SI B11 16 17
Engine

RECALL 17V-683: POSITIVE CRANKCASE VENTILATION (PCV) VALVE HEATER

This Service Information bulletin replaces SI B11 16 17 **dated September 2018**

Repair harness for engine electrical harness:

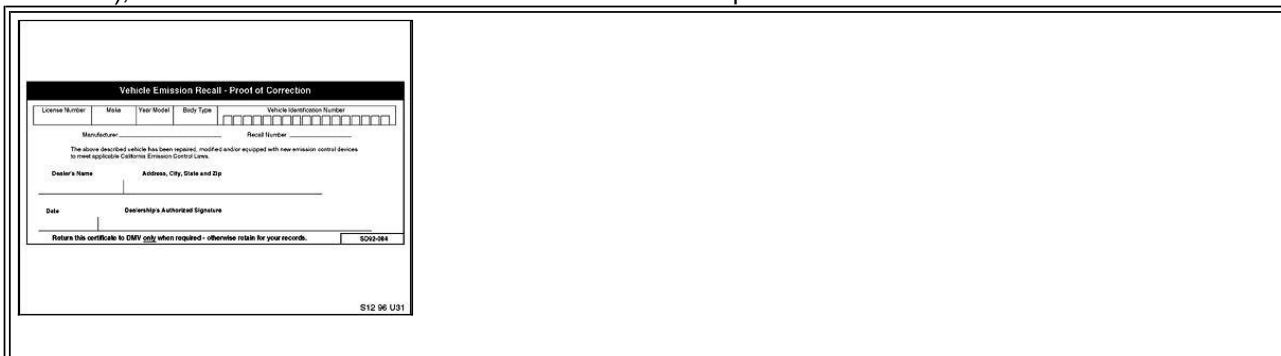
Do not replace the entire engine electrical harness if only the PCV Blow-by-heater (Elbow/Angle Connector) electrical connector is damaged.

Part Number	Description	Quantity
12 52 9 489 752	Repair harness	1
61 13 8 353 748	Cable connector 1.5 - 2.5 mm	2
61 13 1 379 833	Shrinking hose	2
